# UNITED STATES PATENT AND TRADEMARK OFFICE

APPLICATION NO.	FILING DATE	FIRST NAMED INVENTOR	ATTORNEY DOCKET NO.	CONFIRMATION NO.
10/585,722	06/26/2008	Peter Georg Laitenberger	14673-072 US NAT'L	7200
79990	7590	09/03/2009		
C. R. Bard, Inc. Bard Peripheral Vascular, Inc. 1415 W. 3rd Street P.O. Box 1740 Tempe, AZ 85280-1740			EXAMINER WOZNICKI, JACQUELINE	
			ART UNIT 3774	PAPER NUMBER
			MAIL DATE 09/03/2009	DELIVERY MODE PAPER

<b>Office Action Summary</b>	<b>Application No.</b> 10/585,722	<b>Applicant(s)</b> LAITENBERGER ET AL.	
	<b>Examiner</b> JACQUELINE WOZNICKI	<b>Art Unit</b> 3774

## DETAILED ACTION

Annotated Figure 5

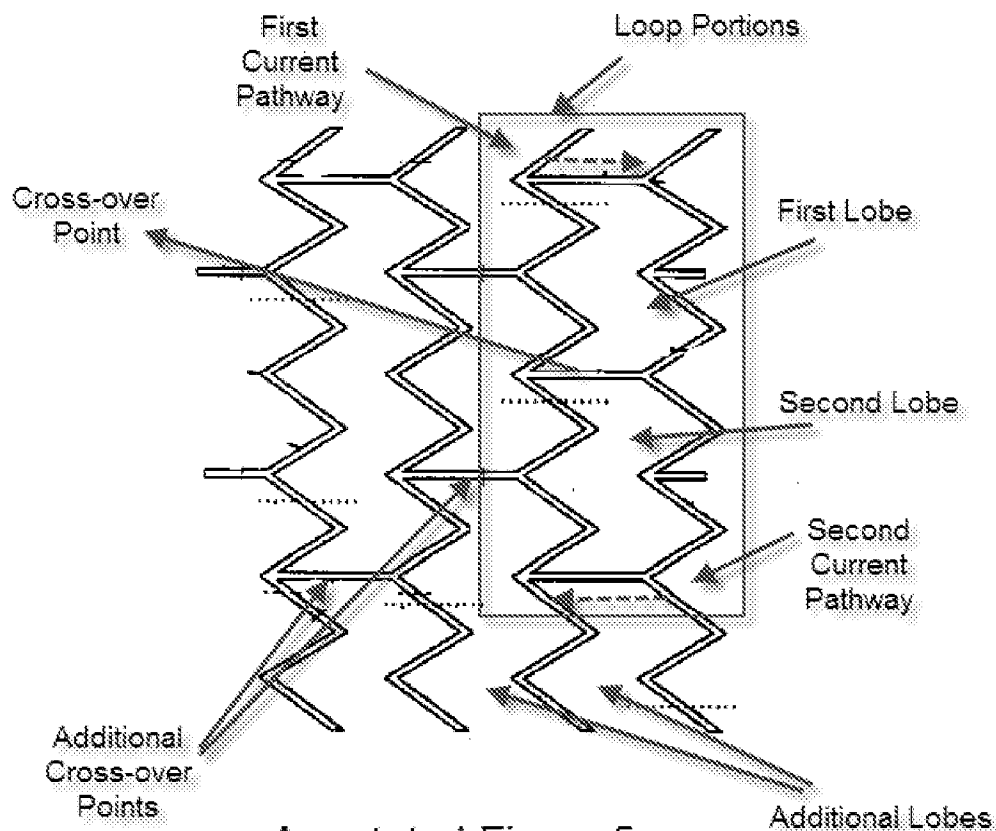
Regarding **claim 1**, Pacetti teaches **an implant comprising:**

**electrically-conductive** (Column 6, lines 5-8) **closed loops** (Figure 5, item 42) **forming an apertured wall** (Figure 5) **of the implant with an interior volume** (Abstract, line 1; a stent is a tube, which has an interior volume), **each of said loops being formed from loop portions** (see Annotated Figure 5, above) **providing electrically- conductive current pathways** (Column 6, lines 5-8) **within which eddy currents are liable to be induced when subjected to a time-dependent external magnetic field** (Column 6, lines 27-29), **each of said loops including a first current pathway and a second current pathway** (Annotated Figure 5) **wherein said first current pathway and said second current pathway are arranged such that, regardless of the direction of said external magnetic field, the direction of the eddy current that would be induced by said field in said second current pathway is the reverse of the direction of the eddy current that would simultaneously be induced by said field in said first current pathway, thereby to prevent flow of eddy currents in each of said loops** (Annotated Figure 5; the directions of the current flowing will be opposite, due to nonconductive connectors present in the loop portion (Column 7, lines 4-7 and 12-14)).

Regarding **claim 2**, Pacetti further teaches each of the loops having loop portions (Annotated Figure 5) formed as a first lobe (Annotated Figure 5) and as a second lobe (Annotated Figure 5) of a figure of eight,

and further comprises a cross-over point (Annotated Figure 5) between said first lobe and said second lobe.

Regarding **claim 3**, Pacetti further teaches an electrically insulating joint (Column 7, lines 4-7 and 12-14) between said two loop portions at the cross-over point (Column 7, lines 2-3; the cross-over point as shown in Annotated Figure 5 is located in a connector).

Regarding **claim 4**, as best understood, Pacetti further teaches each of the loops having additional lobes (Annotated Figure 5) and additional cross-over points between the additional lobes (Annotated Figure 5), with the areas bounded by the lobes being such that, in aggregate, the area bounded by one set of lobes equals the area bounded by a cancelling remainder of the lobes (Figure 2 shows the area represented by the lobes as being symmetrical, and so the area bounded by one will be equal to the another).

Regarding **claim 36**, Pacetti further teaches each of the loops having an even number of lobes (Annotated Figure 5; each loop has two lobes).

Annotated Figure 2

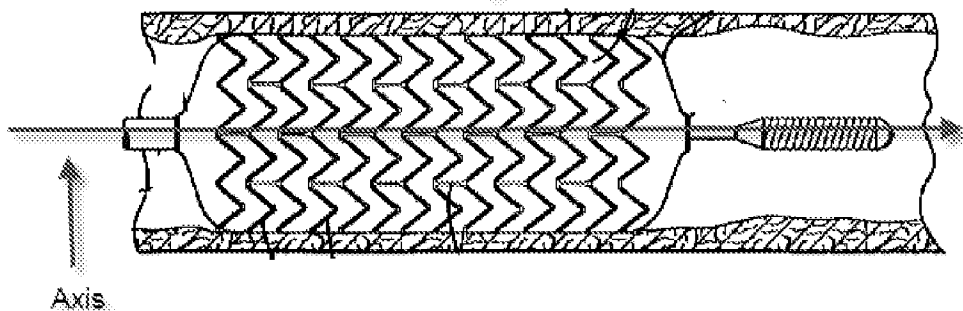
Regarding **claim 5**, Pacetti further teaches the implant having a central longitudinal axis and said interior volume is tubular and centered on said axis (see Annotated Figure 2, above).

Annotated Figure 8

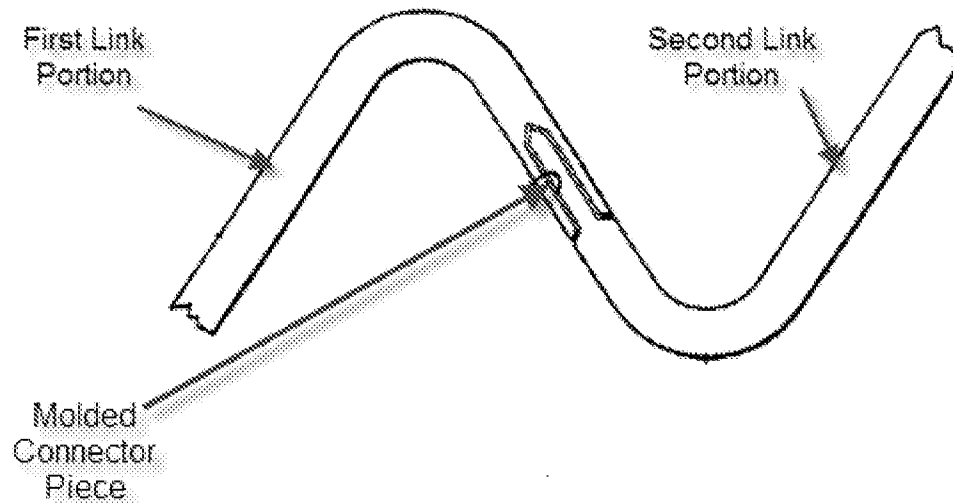
Regarding **claim 15**, Pacetti further teaches each link being a mechanical coupling (Figure 8 and Column 8, lines 7-9) with a first cooperating link portion (see Annotated Figure 8, above) and a second cooperating link portion (Annotated Figure 8).

Regarding **claim 16**, Pacetti teaches the cooperating portions being able to move relative to each other (Annotated Figure 8 and Column 8, lines 7-14; the portions will be able to move relative to each other, for example when the stent is being manufactured and the "tongue" portion is placed in the "groove" portion after they have been cut, the two will be "movable" relative to each other).

Regarding **claim 21**, Pacetti further teaches the mechanical coupling comprising interlocking fingers (Figure 8, item 56 and Column 8, lines 7-9).

Regarding **claim 23**, Pacetti further teaches each link including a molded connector piece (Annotated Figure 8).

Annotated Figure 2d

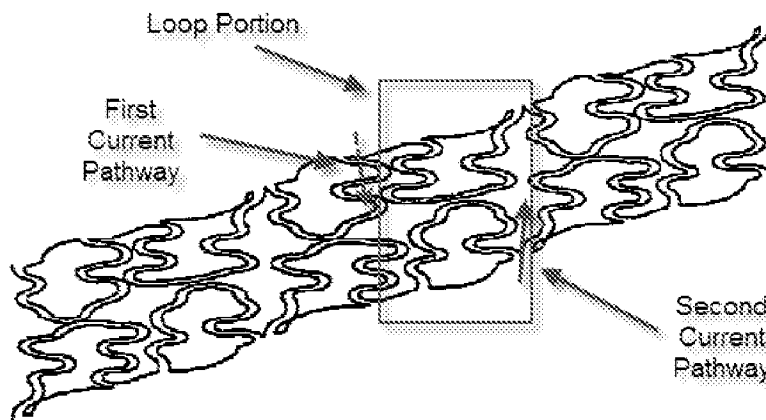
Regarding **claim 1**, Bucker teaches **an implant comprising: electrically-conductive** ([0006]; a metallic material is electrically conductive) **closed loops** (Figures 2a-2e) **forming an apertured wall** (Figure 1) **of the implant with an interior volume** (Figure 1), **each of**

**said loops being formed from loop portions** (see Annotated Figure 2d, above) **providing electrically- conductive current pathways** ([0006]; a metallic material is electrically conductive) **within which eddy currents are liable to be induced when subjected to a time-dependent external magnetic field** ([0003]), **each of said loops including a first current pathway and a second current pathway** (Annotated Figure 2d) **wherein said first current pathway and said second current pathway are arranged such that, regardless of the direction of said external magnetic field, the direction of the eddy current that would be induced by said field in said second current pathway is the reverse of the direction of the eddy current that would simultaneously be induced by said field in said first current pathway, thereby to prevent flow of eddy currents in each of said loops** ([0017]; because the endoprosthesis does not form a closed circuit, current will not flow).
